ADDENDUM NO. 3

TO: PLANS AND SPECIFICATIONS FOR STATE OF MISSOURI

**USB Roof Replacement & Latrine Renovation
Chillicothe Readiness Center
1500 Washington St.
Chillicothe, Missouri 64601
PROJECT NO.: T2519-01**

September 2, 2026

SHEET TITLE:
SITE GRADING PLANS

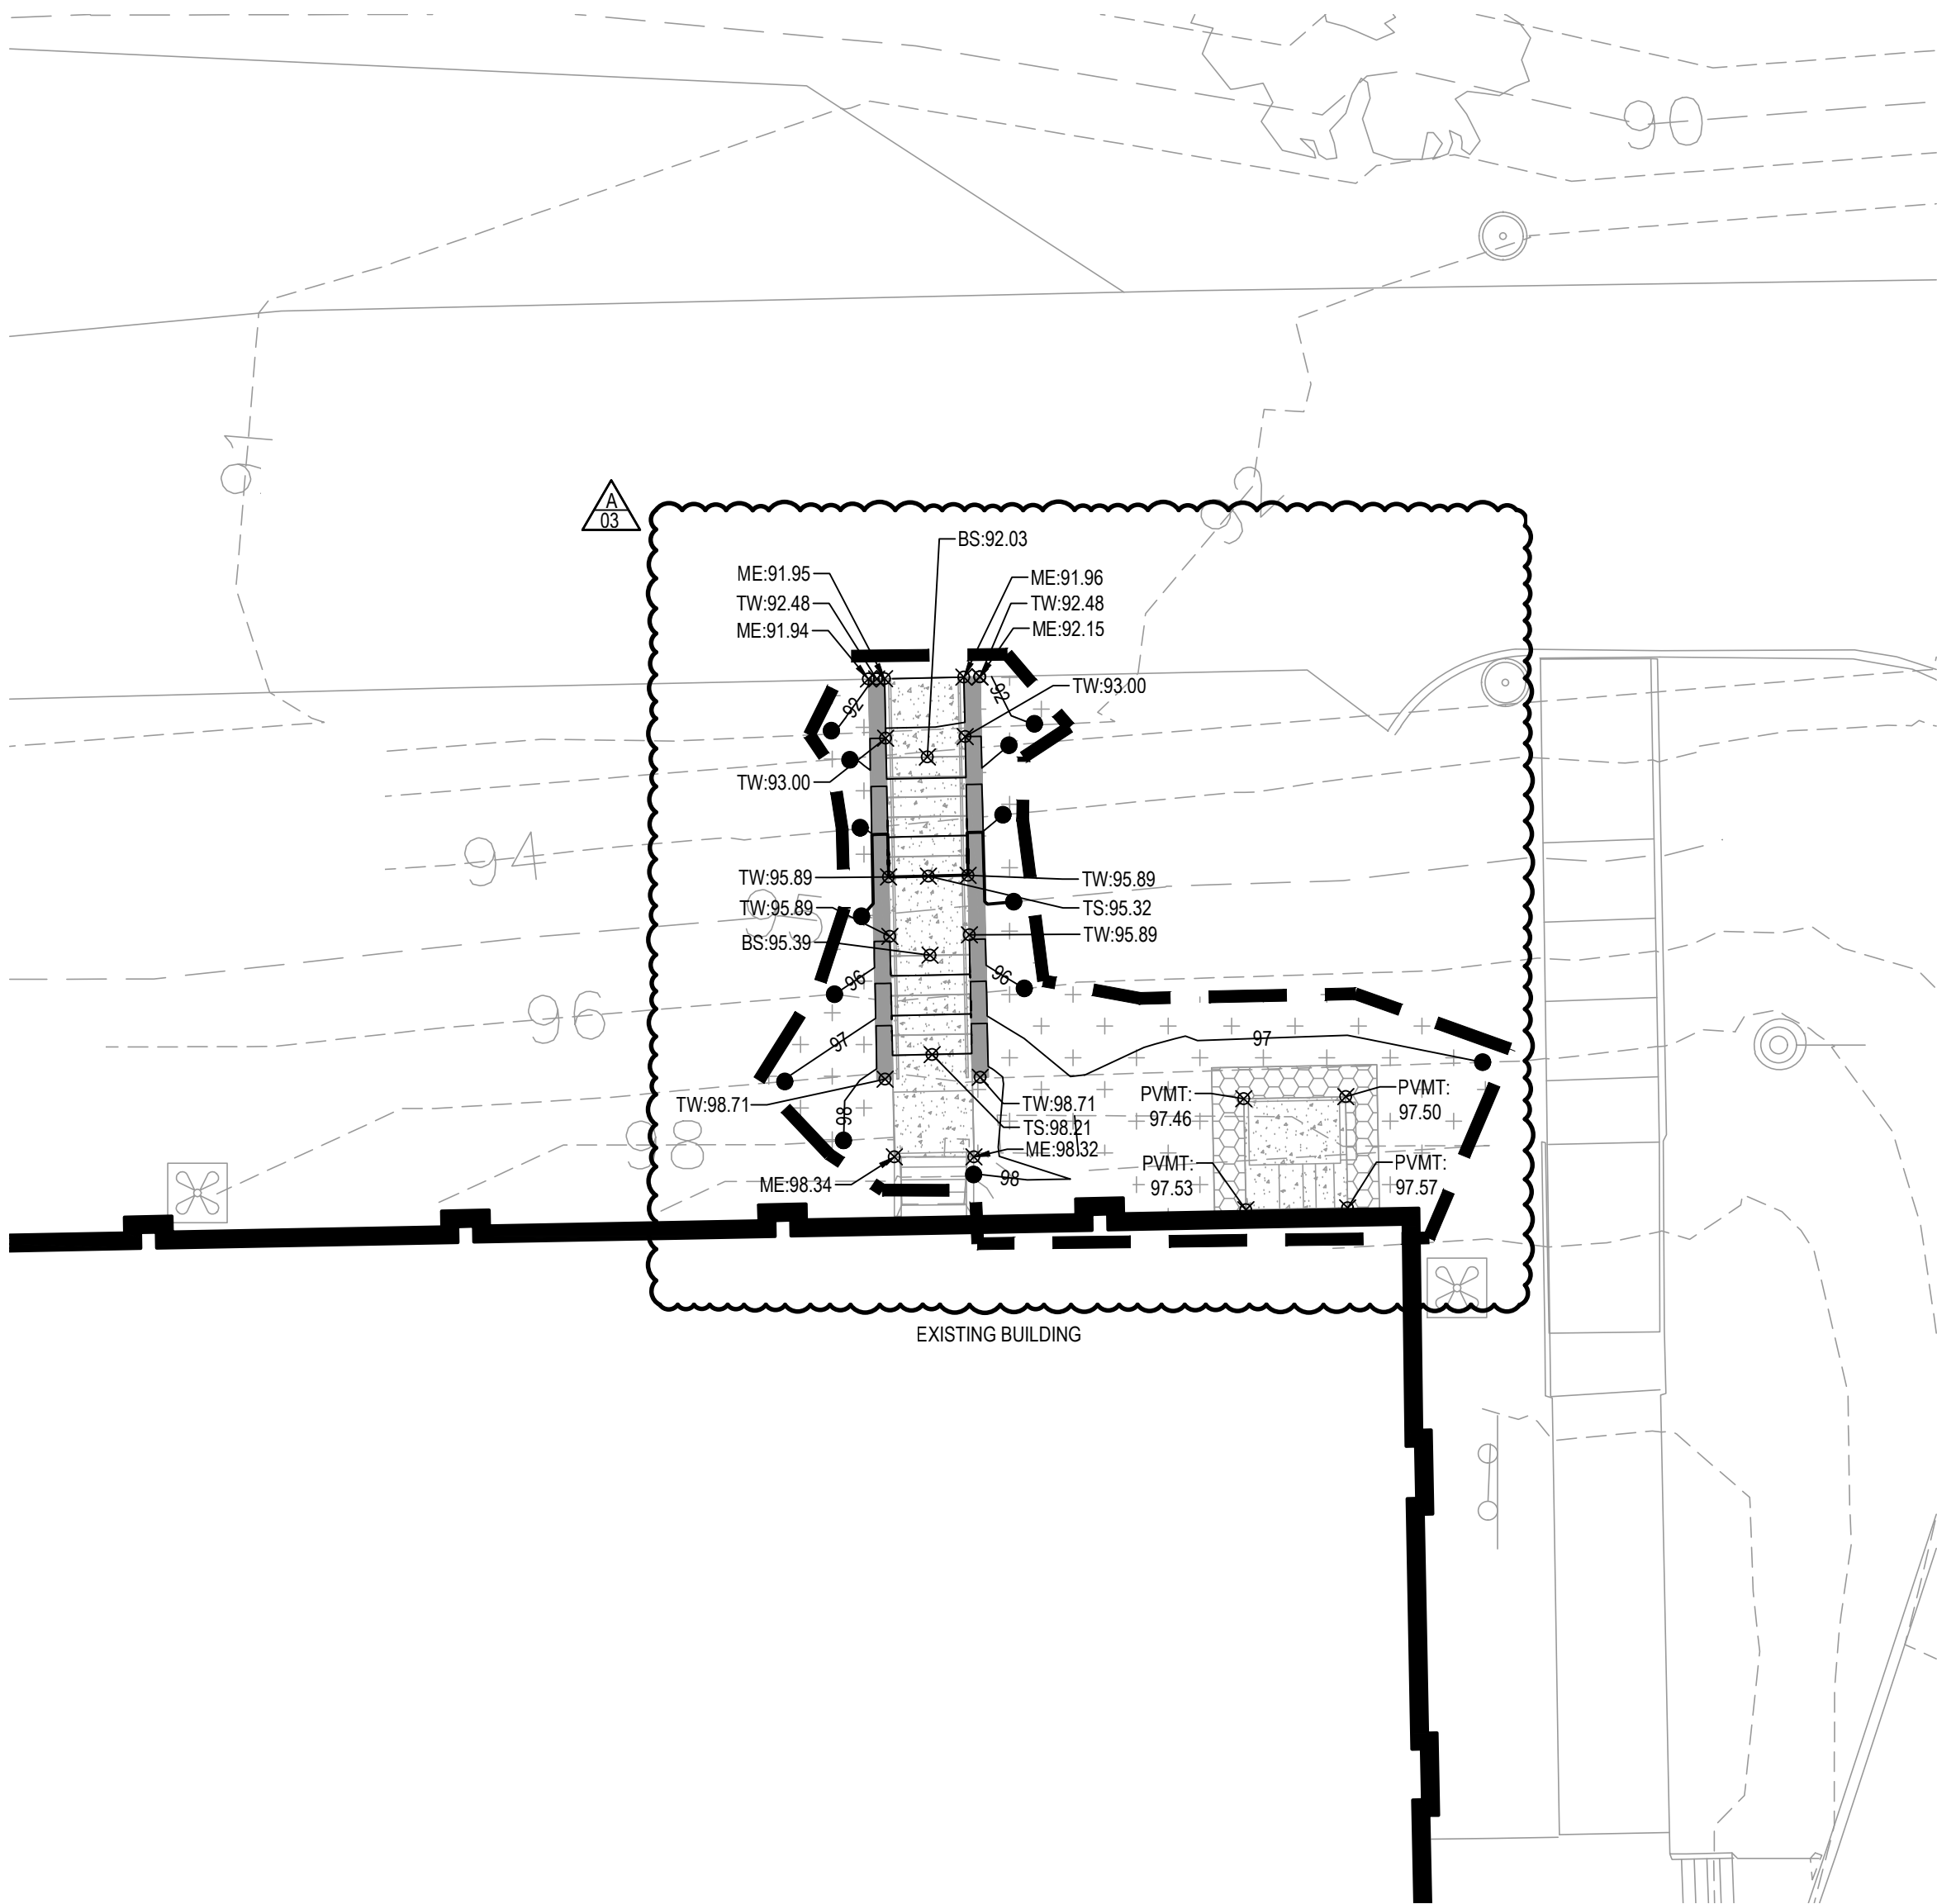
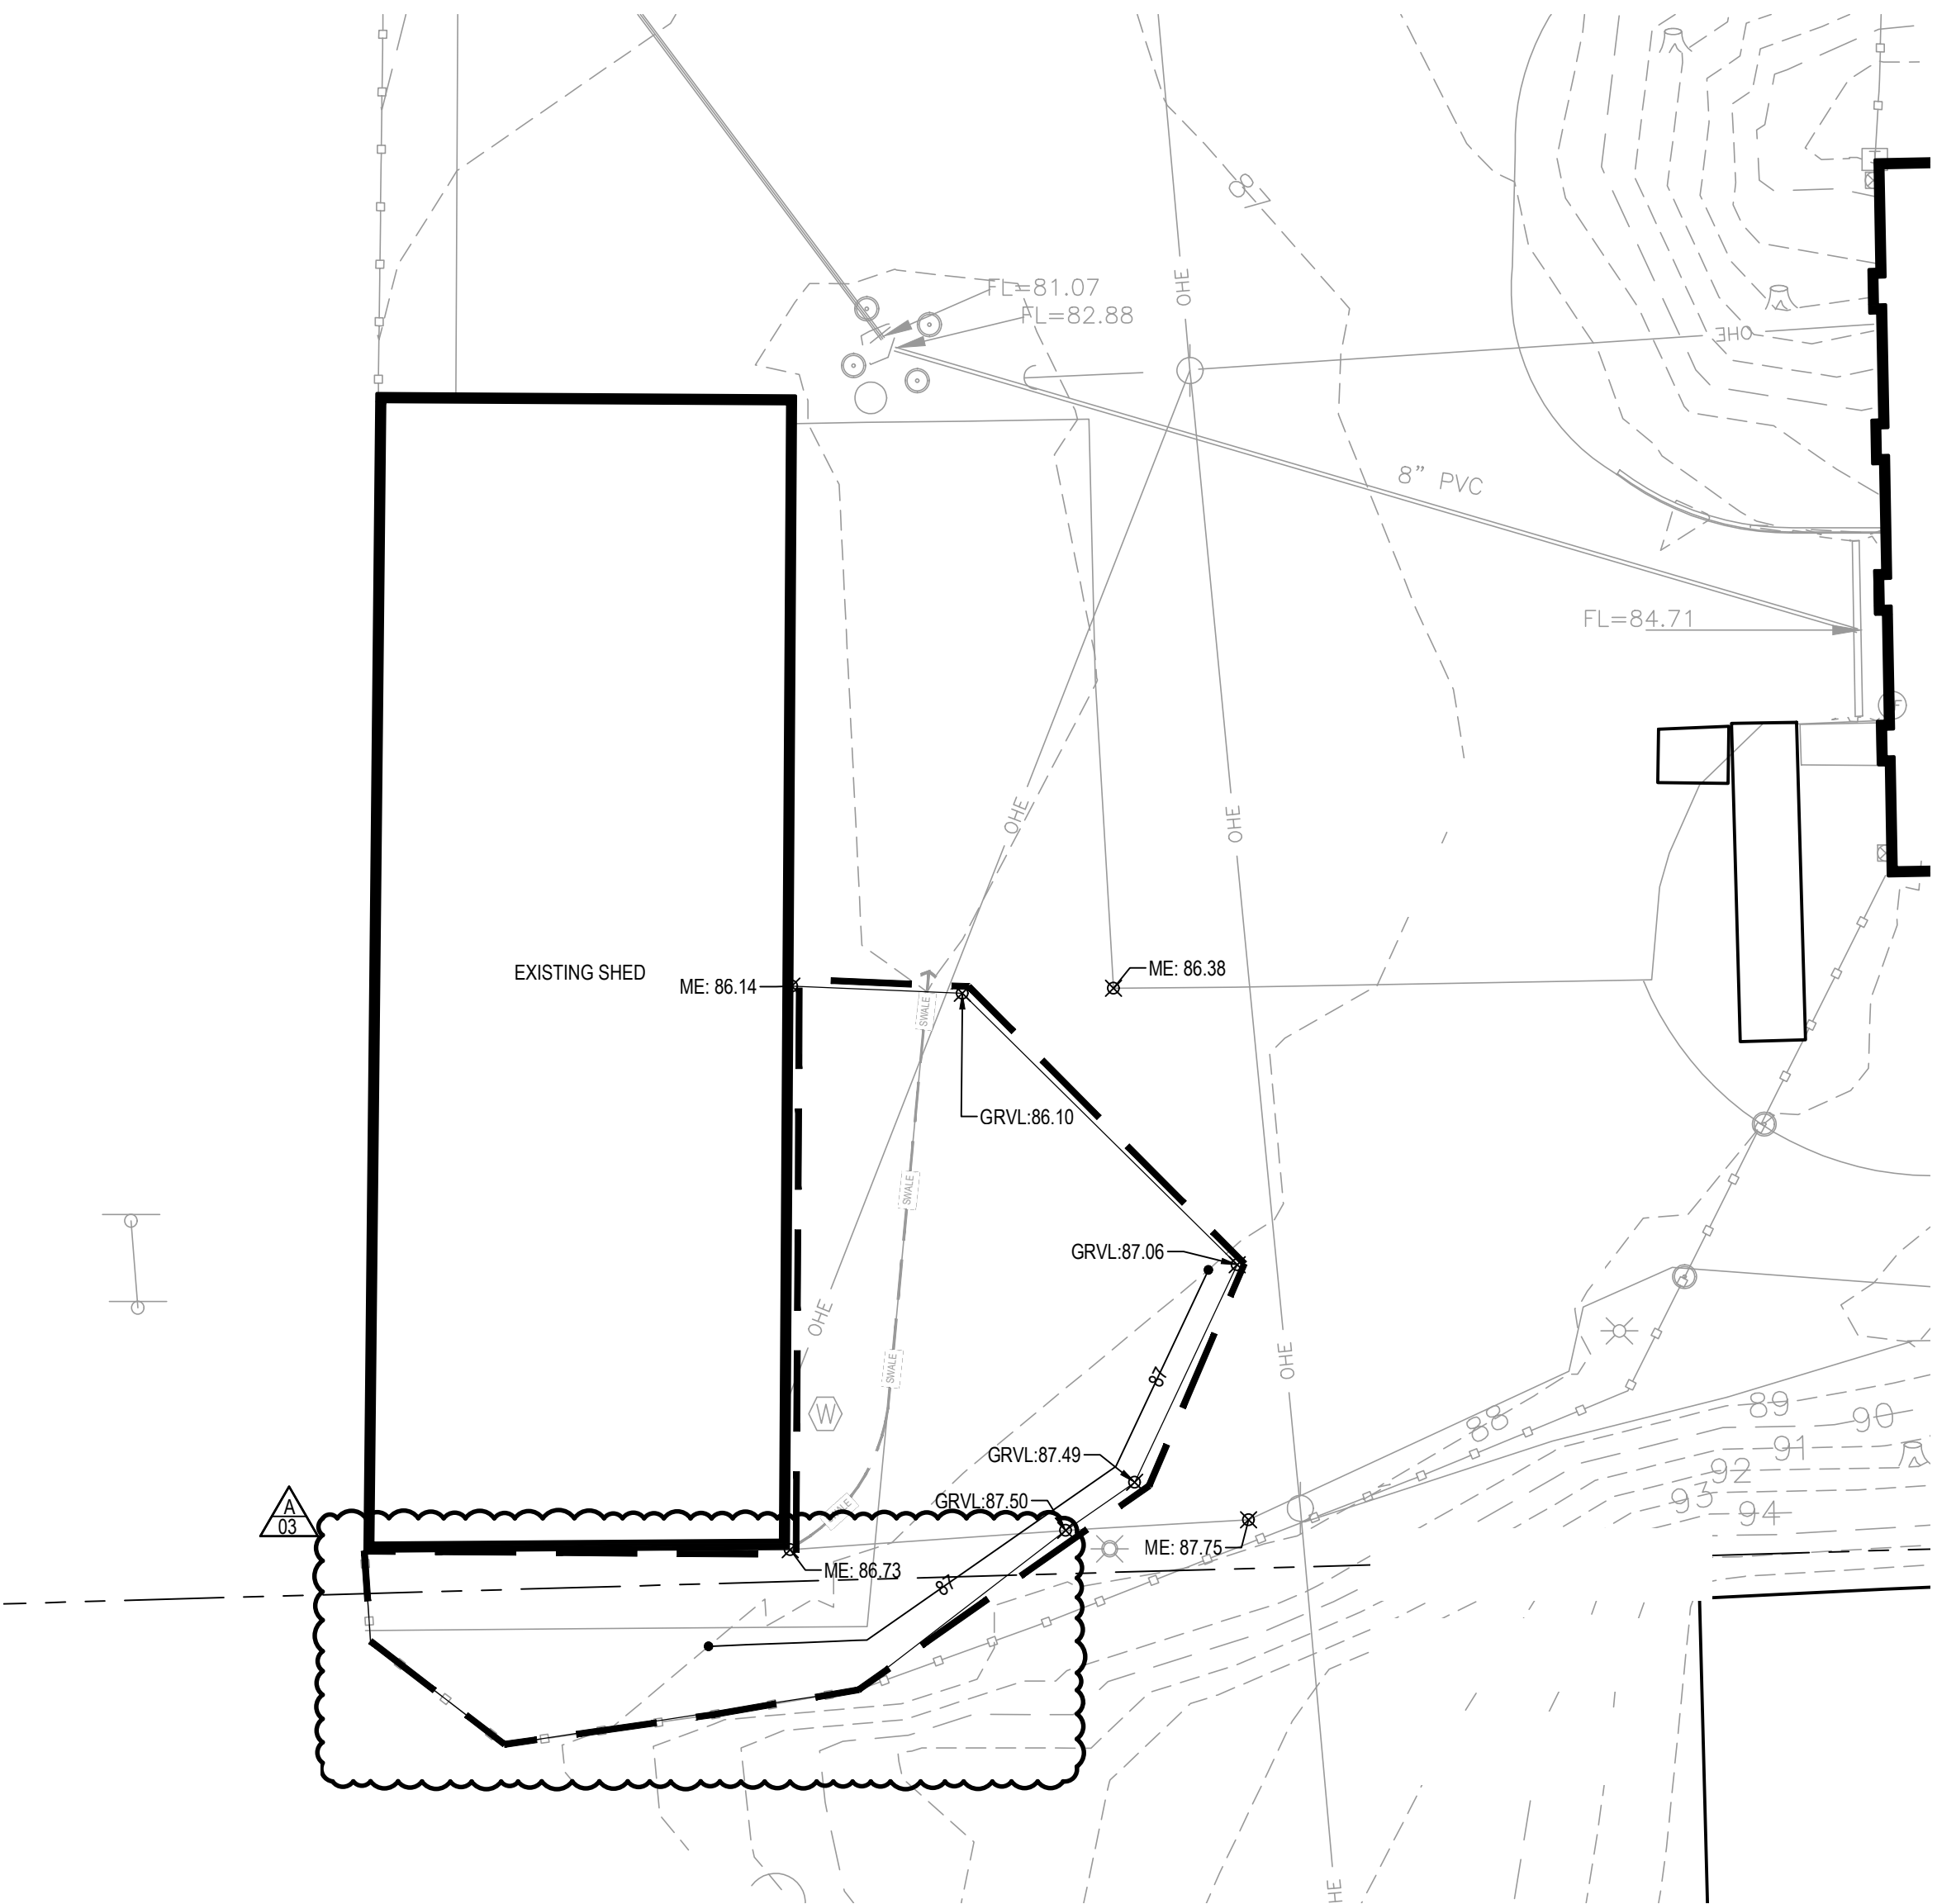
1. Sheet L-101 – Existing Conditions and Demolition Plan
 - a. ADDED demolition of existing north stair landing.
2. Sheet L-201 – Site Layout Plans
 - a. REVISED site conditions.
3. Sheet L-301 – Site Grading Plans
 - a. REVISED site conditions.
